**Correspondence Between
Staff and Applicant
Approval Letter**

RE: 14-PP-2017
Wolf Springs Ranch

The Planning & Development Services Division has completed the review of the above referenced development application submitted on November 15, 2017. The following **1st Review Comments** represent the review performed by our team, and is intended to provide you with guidance for compliance with city codes, policies, and guidelines related to this application.

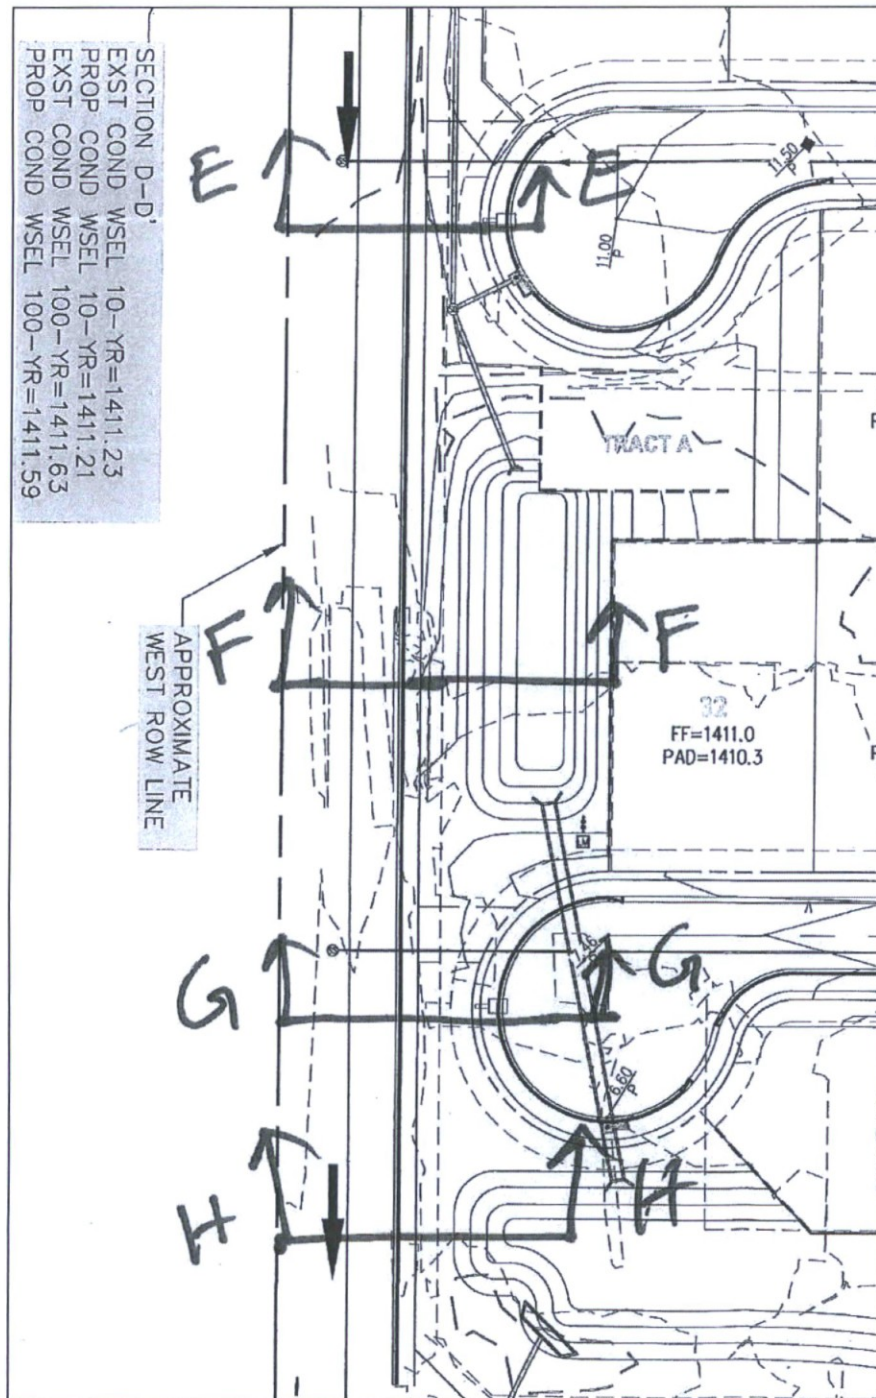
10. Please add four (4) more cross-sections (marked up as Cross-Section E-E through H-H on the redlined exhibit EX-3C as shown below. Please analyze these XS(s) in FlowMaster as well. Please demonstrate that the offsite flow along 93rd Street will not break out into the two proposed detention basins under the 100-year storm event. Please analyze hydraulics for the full street instead of the half street, if necessary. [Reference: COS DS&PM: Section 4-1A]
